A PROPOSED NEW HOME
18151 OVERLOOK ROAD
LOS GATOS □ CALIFORNIA

April 29, 2015

RE: 18151 Overlook Road

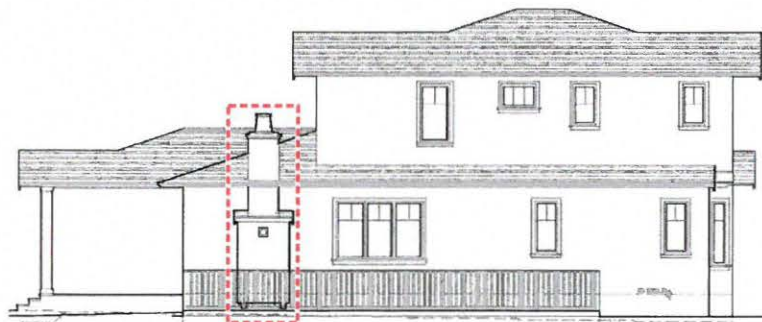
The only concern that I see is that the design of the gas fireplace chimneys are not consistent with Residential Design Guideline 3.10.4.

Chimneys are not consistent with Residential Design Guideline 3.10.4

Recommendation: Design the two fireplace chimneys to be compatible with traditional Craftsman Style homes.

Proposed Right Side Elevation

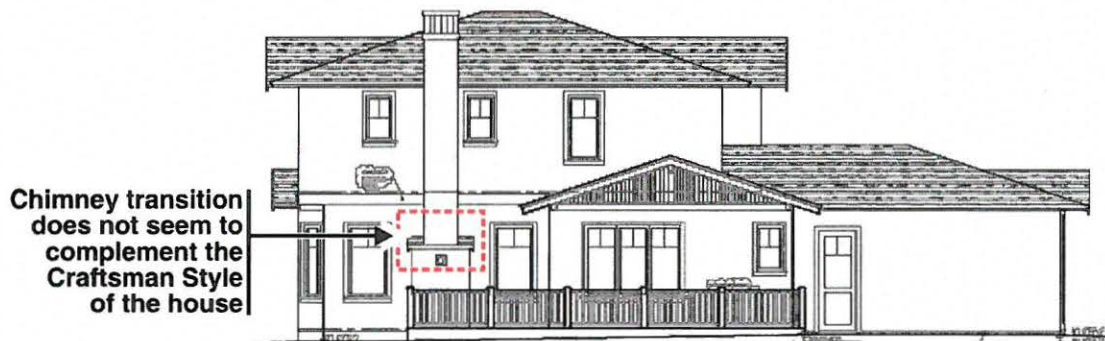
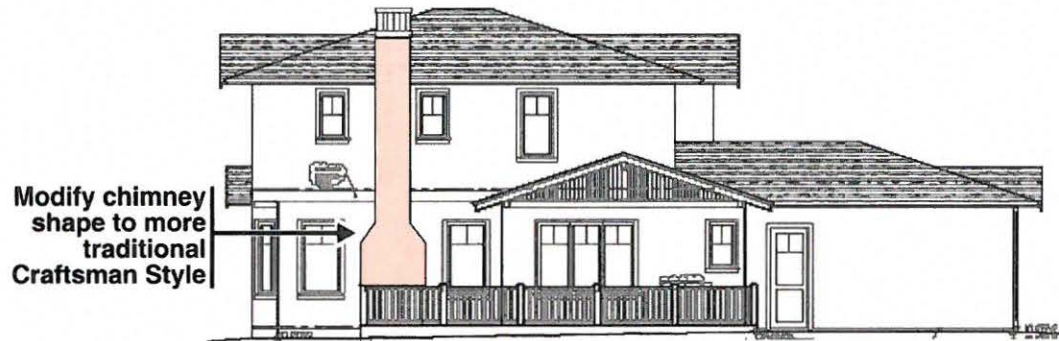
The only concern addressed in my review letter of April 29 was that the design of the gas fireplace chimneys are not consistent with Residential Design Guideline 3.10.4. The concerns were addressed by eliminating the chimney on the right side elevation and extending the chimney on the left side elevation. My only lingering concern is that the shed roof transition between the fireplace firebox and the chimney seems a bit out of character with the Craftsman Style details at the roof gable ends.

Recommendation: Design the fireplace chimney transition to be compatible with traditional Craftsman Style homes. One approach is shown below, and others (e.g., non-symmetrical) are possible.

Revised Front Elevation - with shingles and stone in lieu of stucco

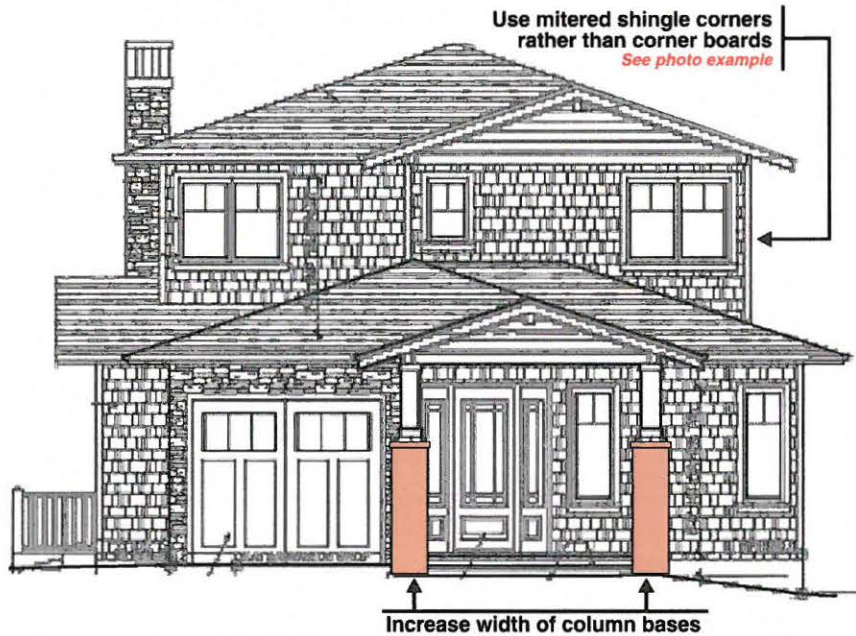
I am comfortable with the substitution of shingles for the stucco so long as they are traditional wood shingles rather than manufactured fiber cement shingles. And, the use of stone is also consistent with the architectural style and the Town's Residential Design Guidelines. I have only two concerns.

1. The stone column bases seem too small for the architectural style.
2. The use of corner boards where the shingles turn corners is not the best looking detail.

1. *Increase the size of the stone column bases. Two suggestions are shown below. Either option would be acceptable.*
2. *Use mitered shingle corners rather than corner boards. This is a common detail for similar homes in Los Gatos.*
